PROJECT COMMENTS

DATE: 3/25/2021

PROJECT NUMBER: SP2021-008
PROJECT NAME: Site Plan for Rockwall Friendship Baptist Church
SITE ADDRESS/LOCATIONS: 5645 STATE HIGHWAY 276, ROCKWALL, 75032

A3.00

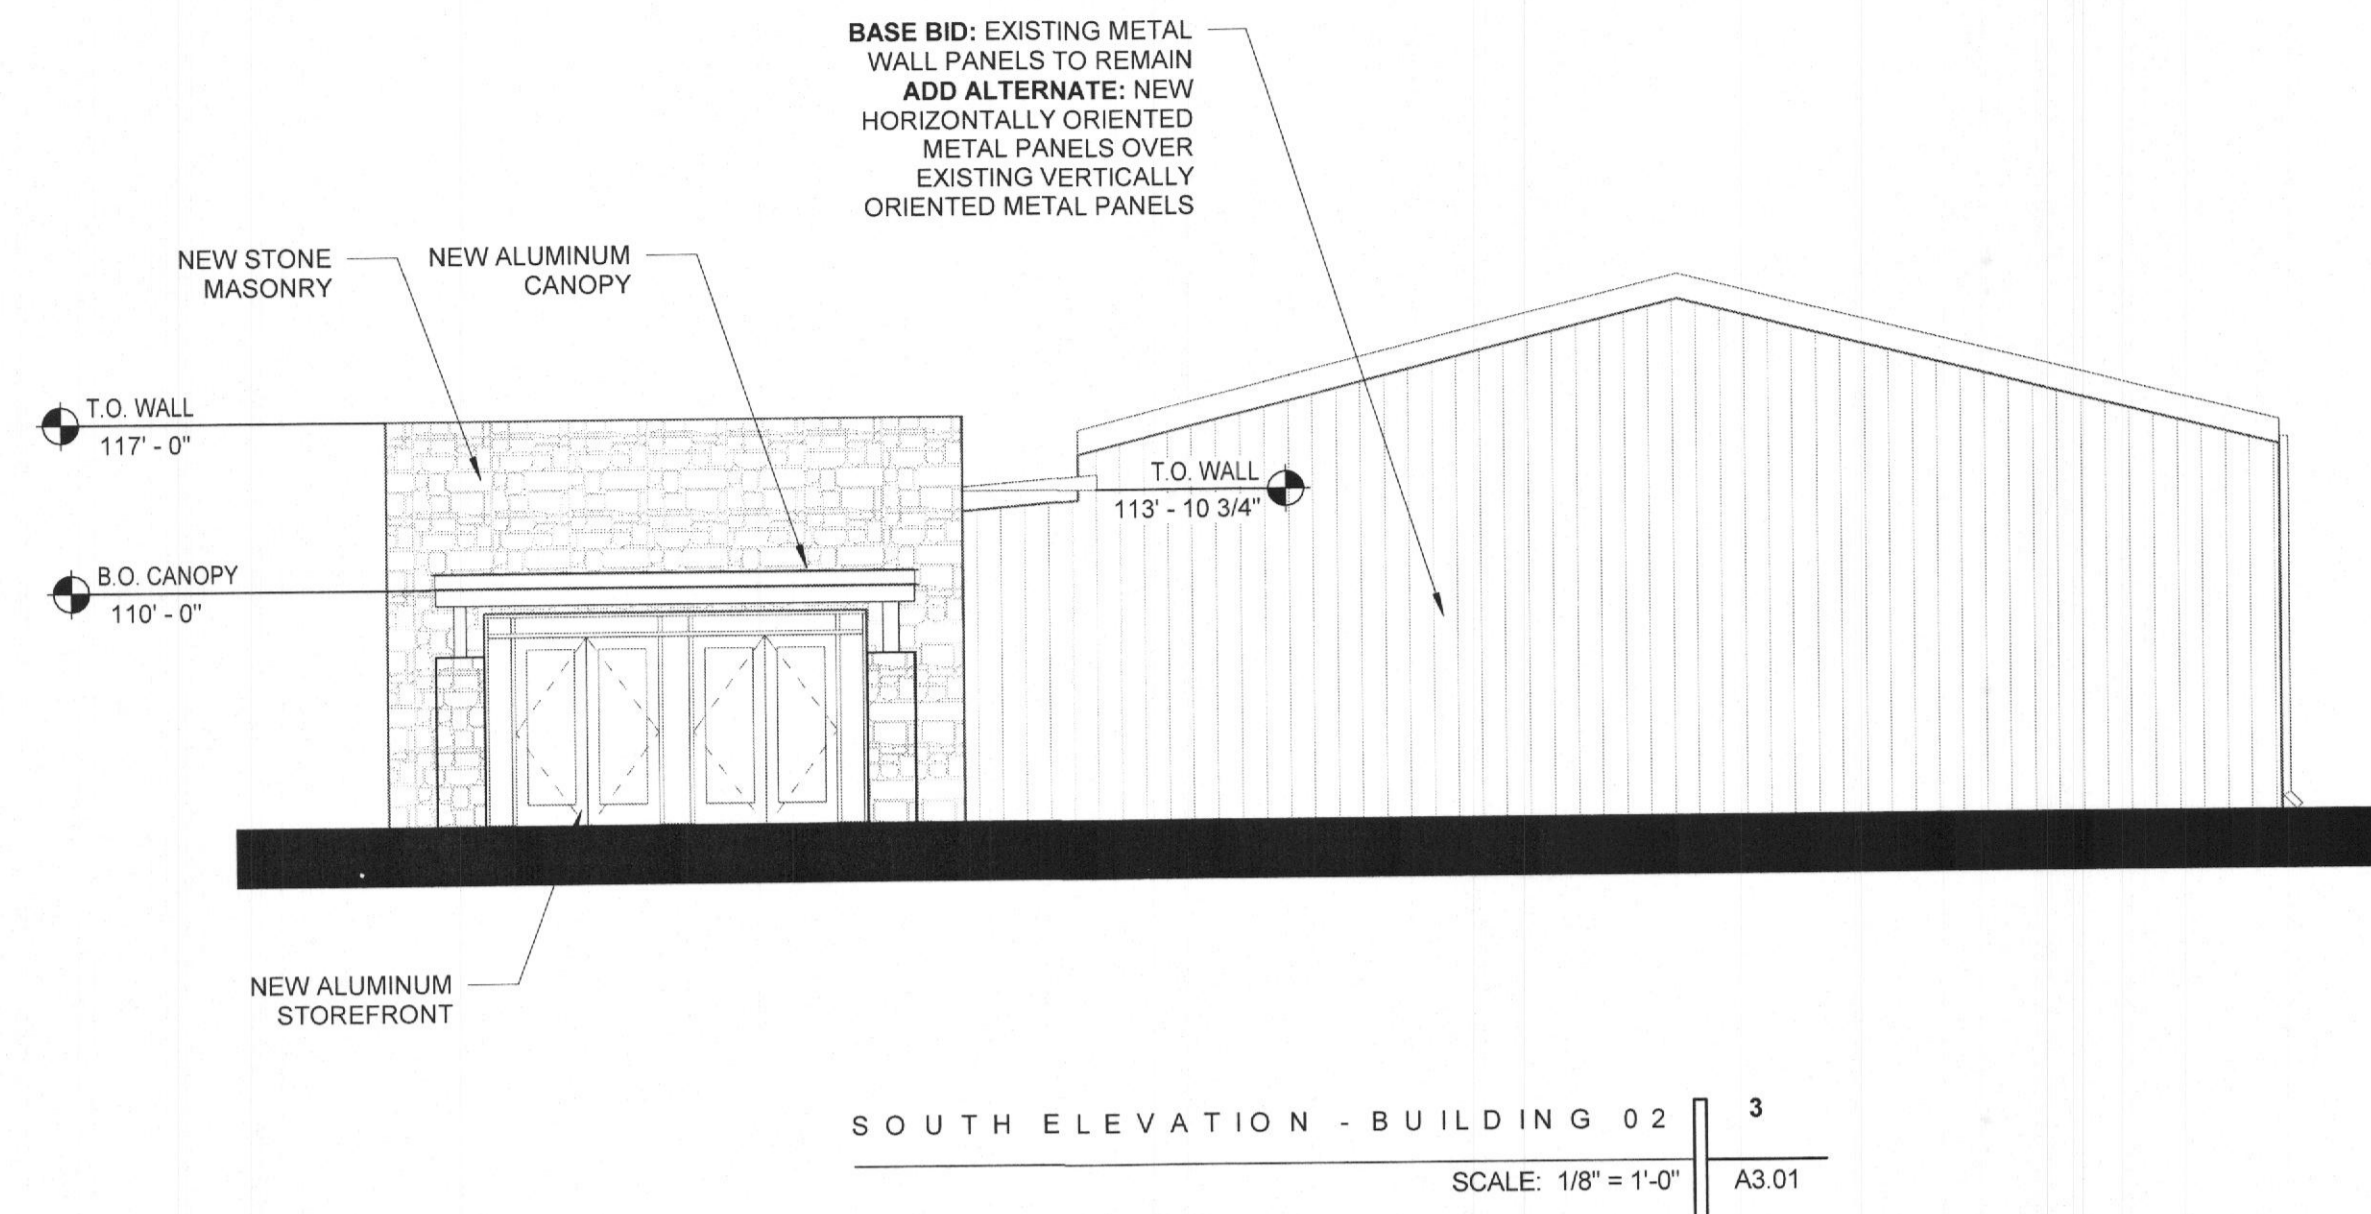
1. Each elevation must include a minimum of 90% masonry material; this would apply to the new addition. If this is not met on all sides of the proposed addition a variance would need to be requested and two (2) compensatory measures would need to be provided. (Subsection 06.02. C, of Article 05)

2. Indicate the surface area (square feet) of each façade and the percentage and square footage of each material used on that façade. (Subsection 04.01, of Art. 05)

3. Indicate any proposed roof mounted mechanical equipment and indicate how these will be screened from view. Consider crosshatching on the elevations where any roof mounted units will be located. (Subsection 01.05. C, of Article 05)

4. The proposed addition does not meet the horizontal articulation requirements. This would be a variance to the code requiring two (2) compensatory measures. (Subsection 04.01. C. A, of Article 05)

FRIENDSHIP BAPTIST CHURCH
 5651 SH 276, ROCKWALL, TEXAS
 PRELIMINARY ENGINEERING - DRAINAGE

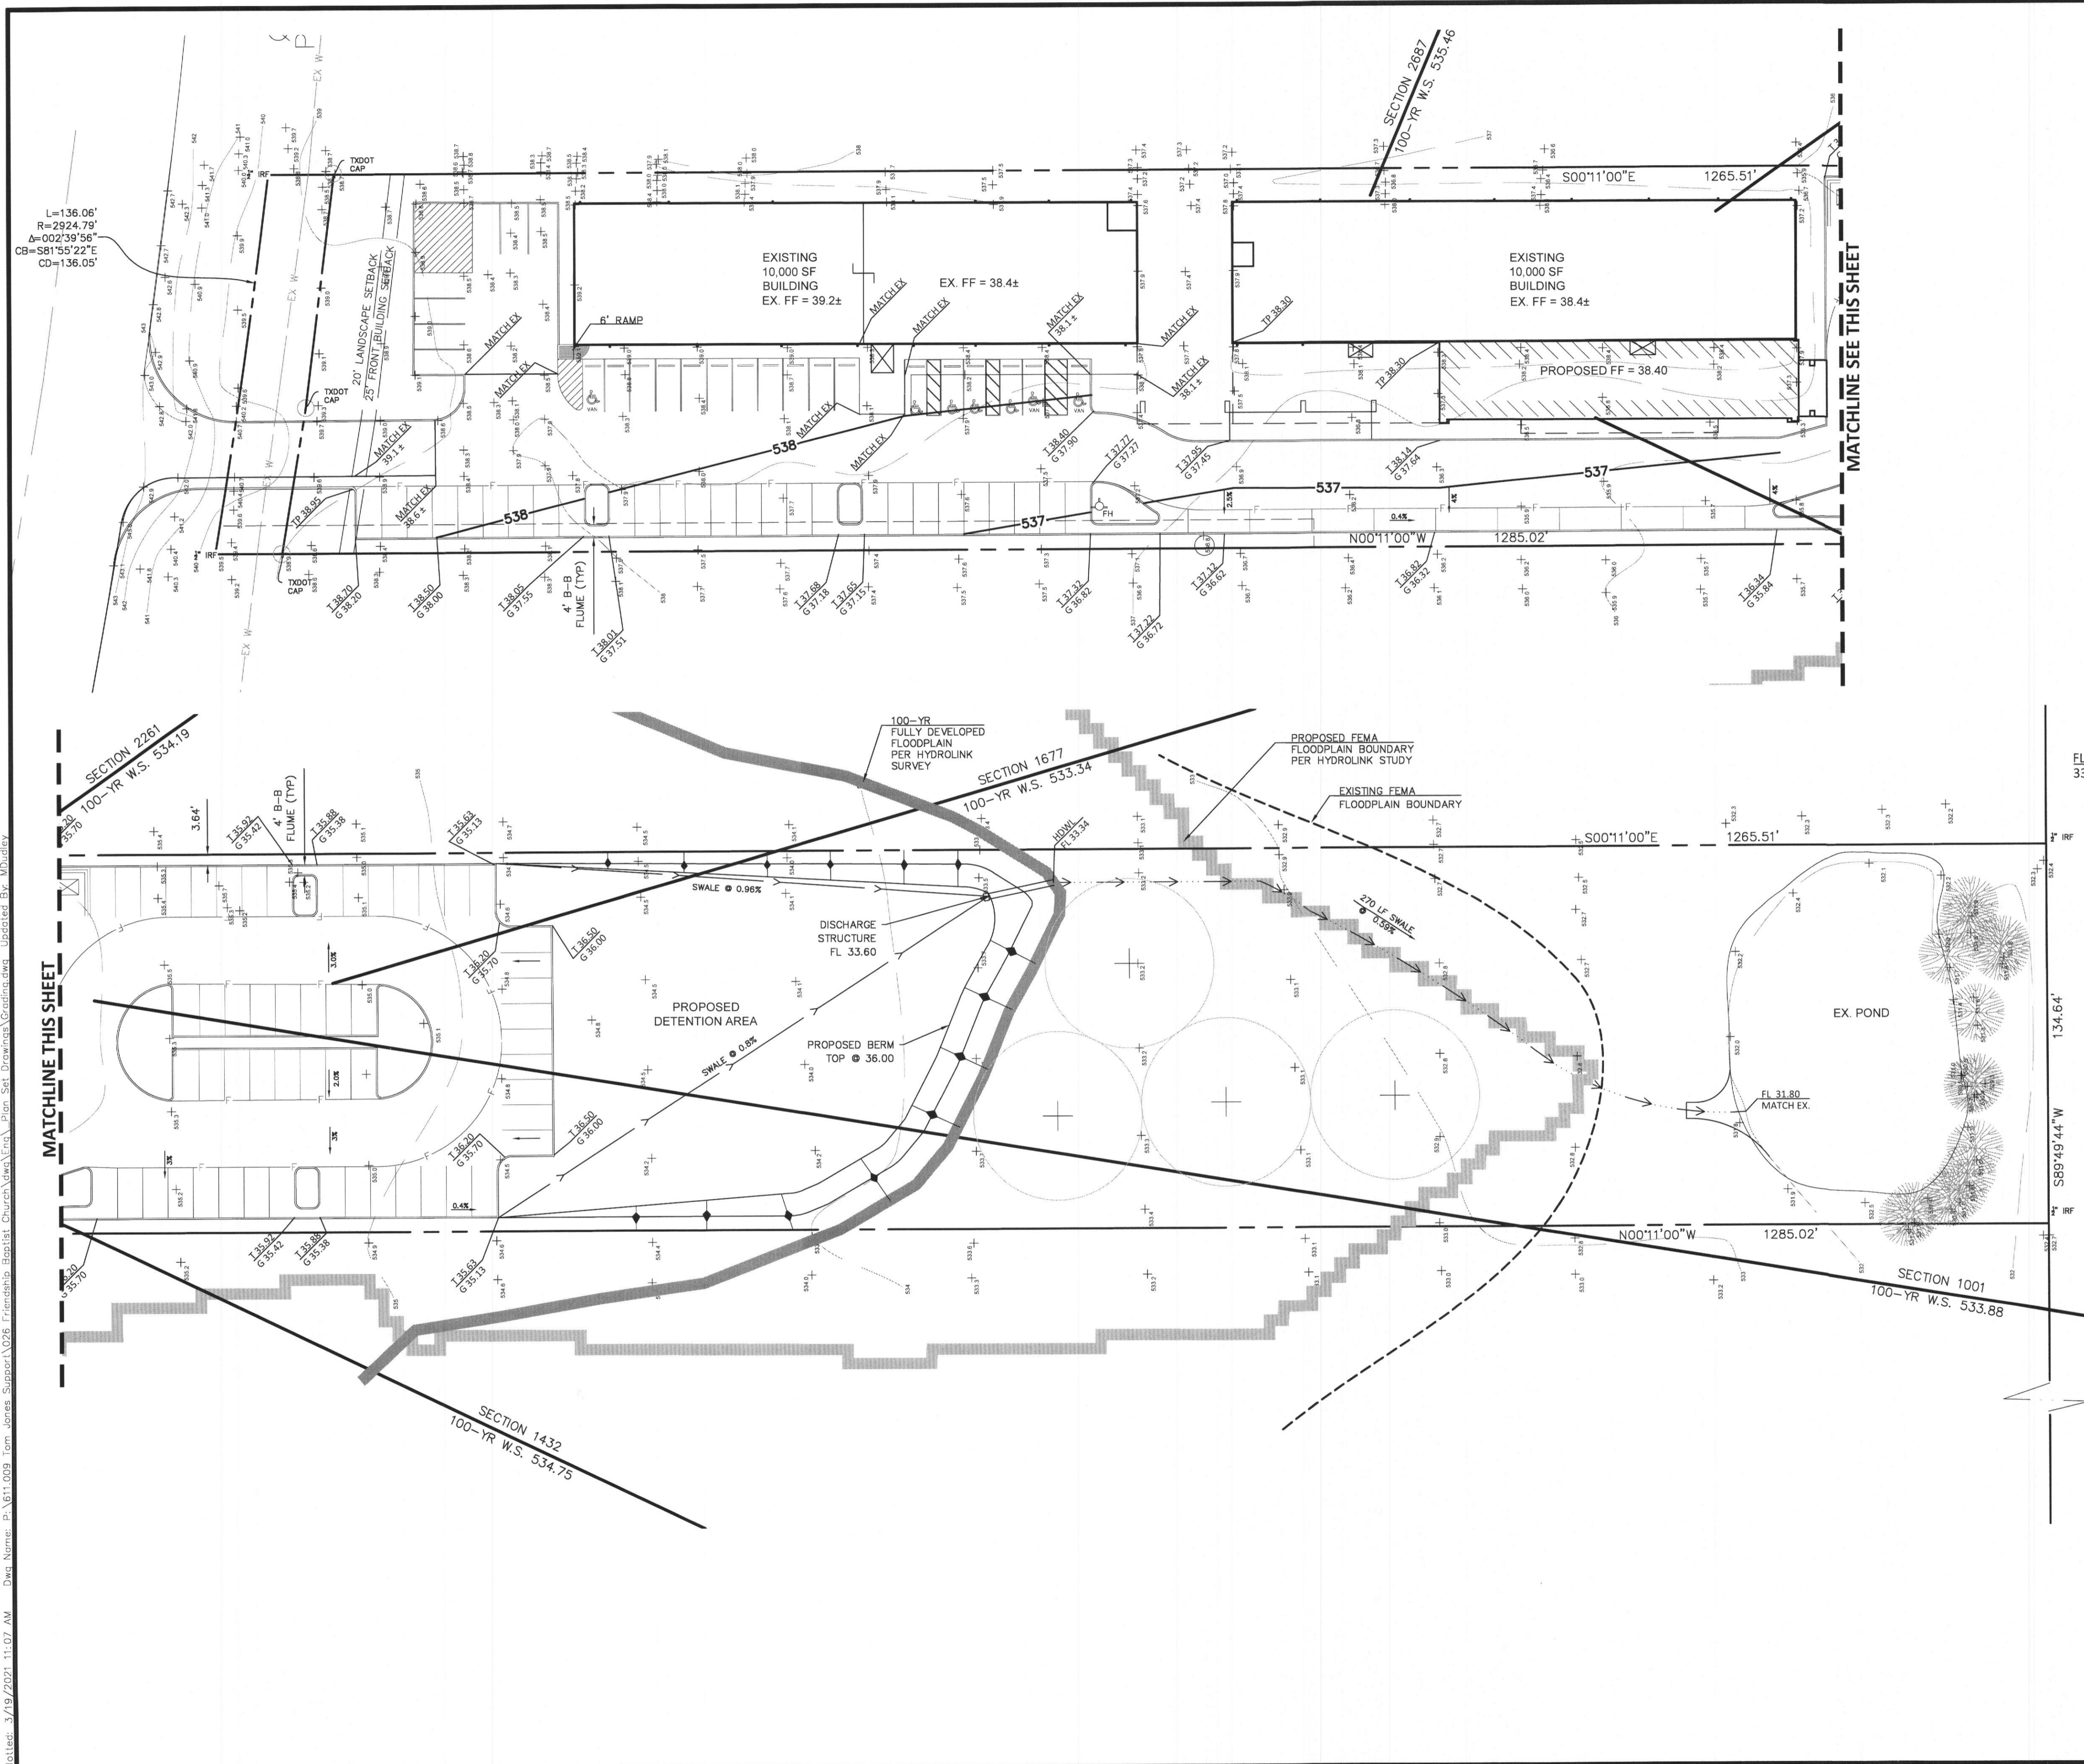
M - Existing aerobic spray fields? If they are proposed, they may not be allowed in the floodplain limits.

I - Detention is required for new paving and building expansion.

- I - No detention, grading, filling, etc. in the floodplain
- I - Flood study will be required to delineate the 100 yr. fully developed flood plain. Review retainer will be due with 1st submittal.
- I - Manning's C-value is per zoning type.
- I - Dumpster areas to drain to oil/water separator and then to the storm lines.

FRIENDSHIP BAPTIST CHURCH
 5651 SH 276, ROCKWALL, TEXAS
PRELIMINARY ENGINEERING - UTILITIES

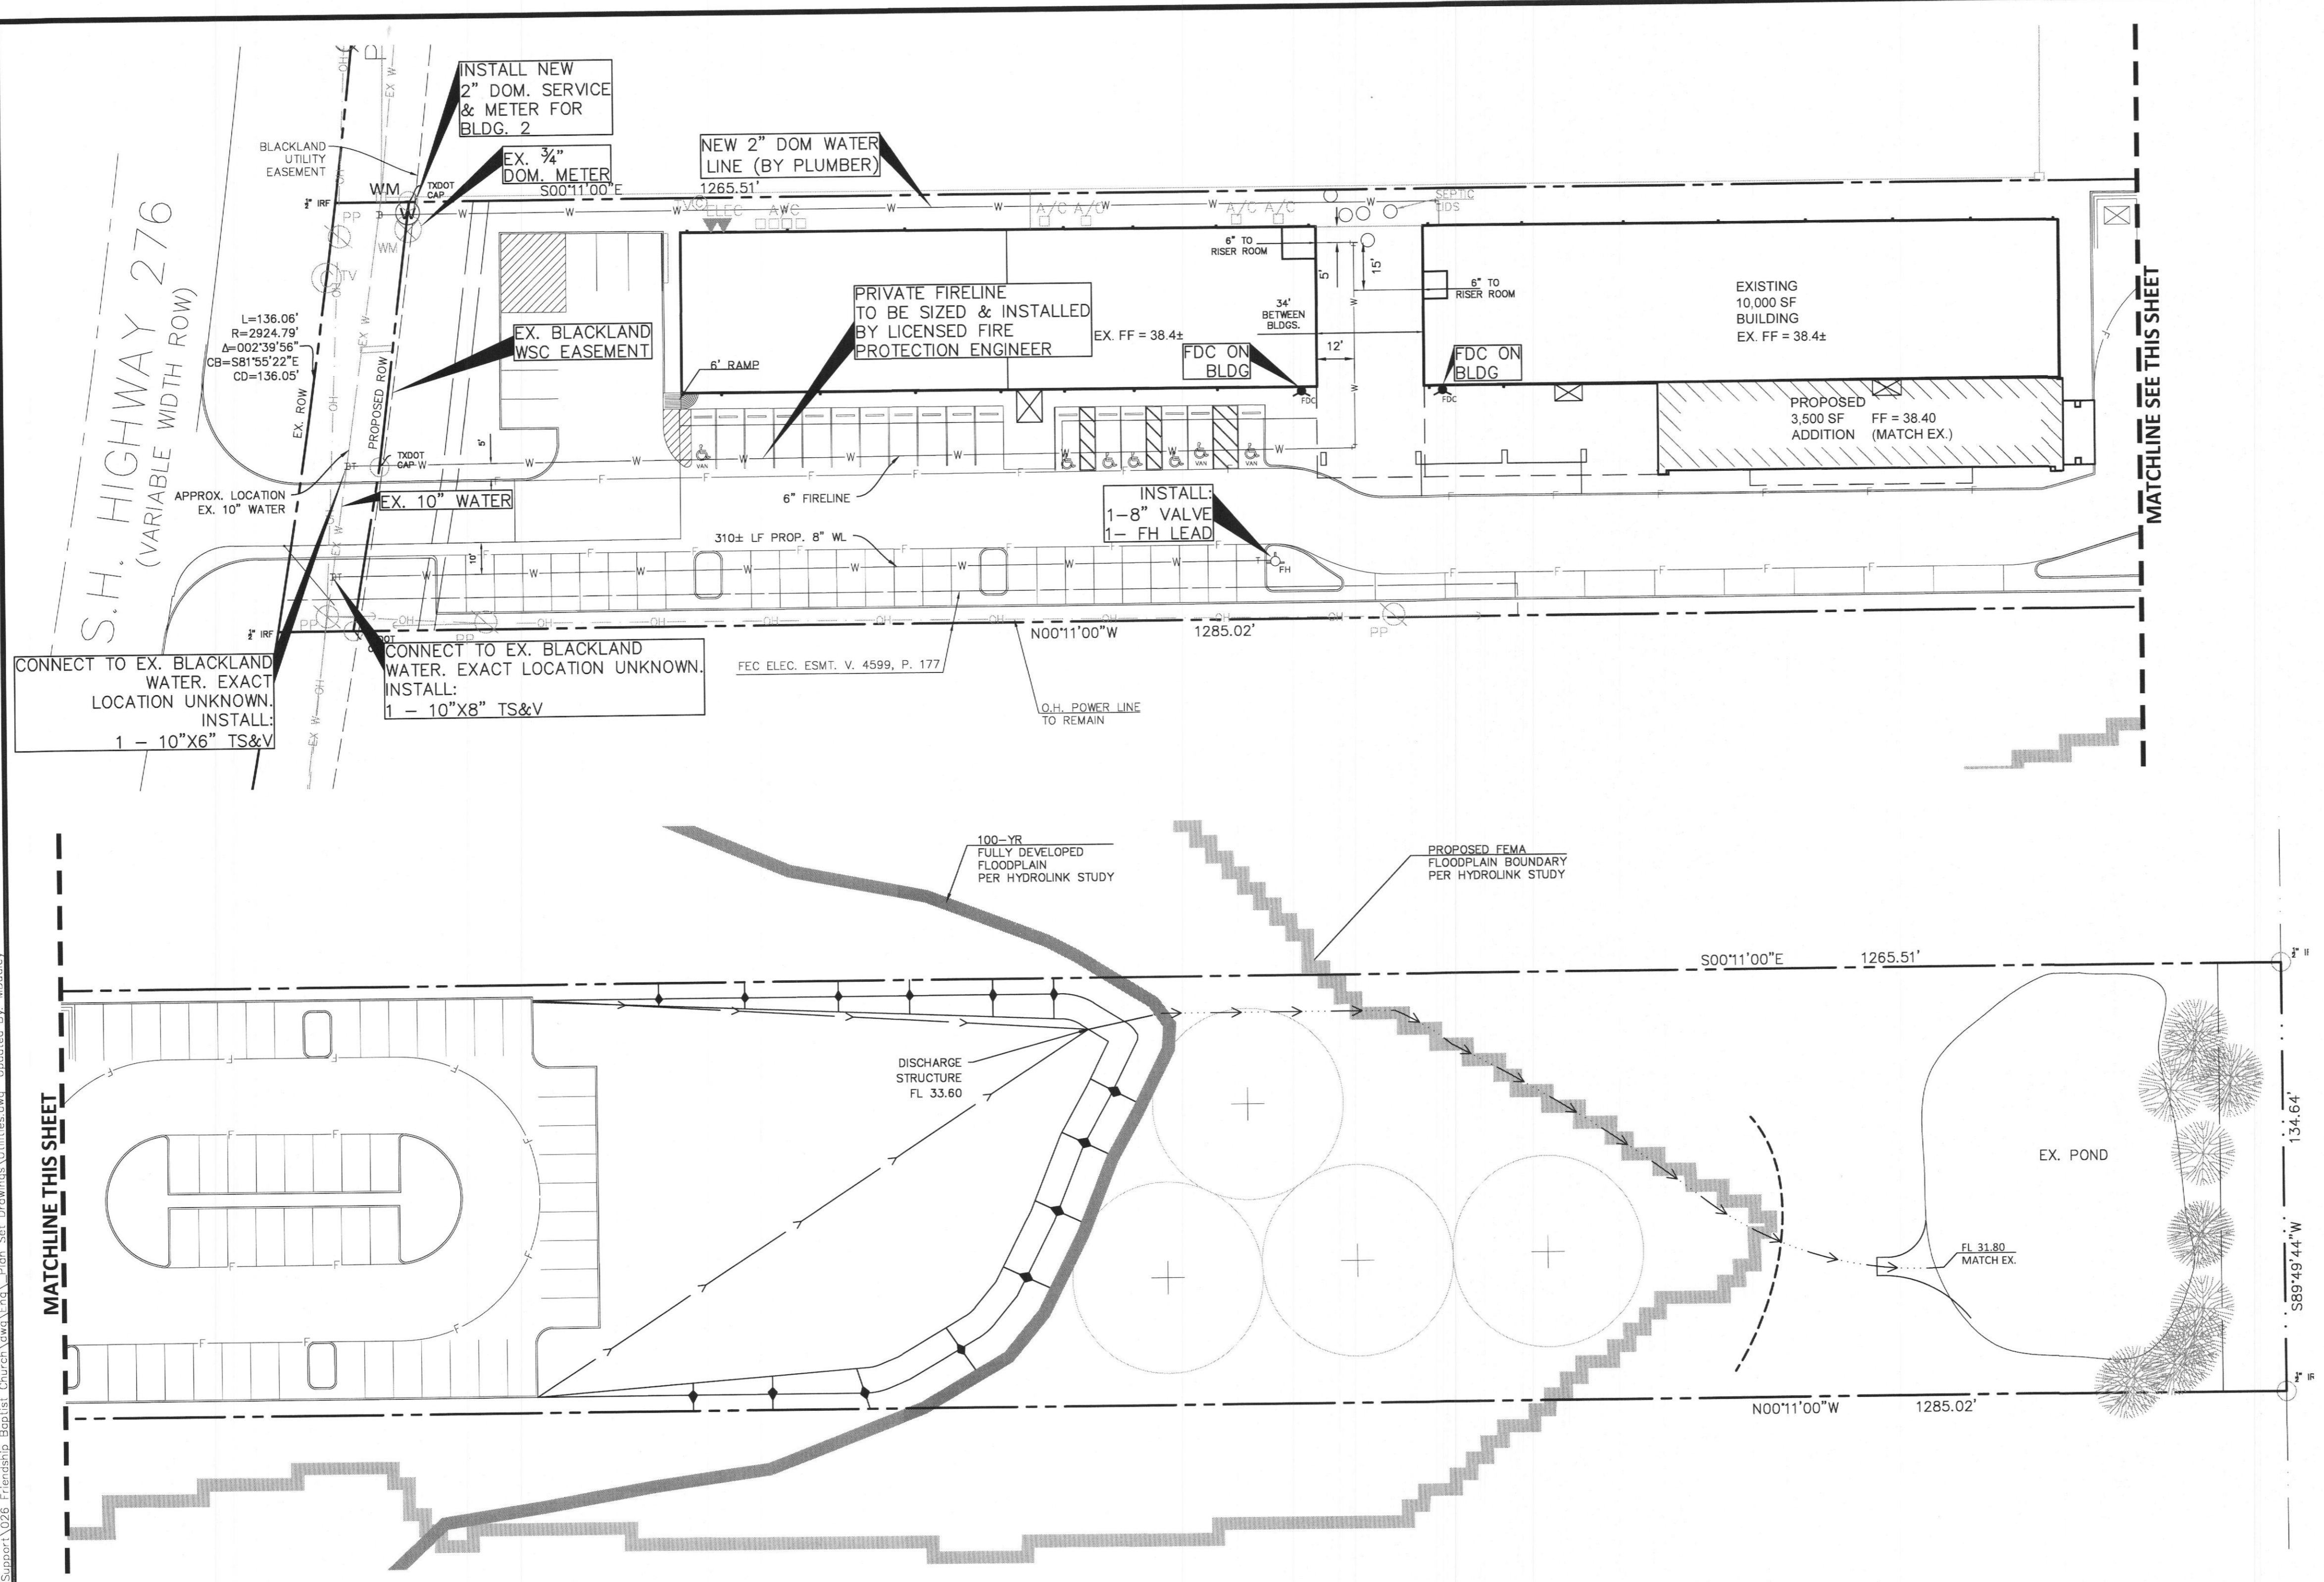
M - Must show existing and proposed utilities.

- M - Show proposed utility lines (Water, Sewer, etc.)
- I - No additional water meters allowed until Blackland get an approved contract with City of Rockwall.
- I - Need letter from Rockwall County stating that the existing OSSF has the capacity for the expansion.
- I - Any water lines extended to supply fire protection and service must be a minimum of 8", looped, and must be in a 20' wide easement. (Meet City of Rockwall Standards of Design and Construction)
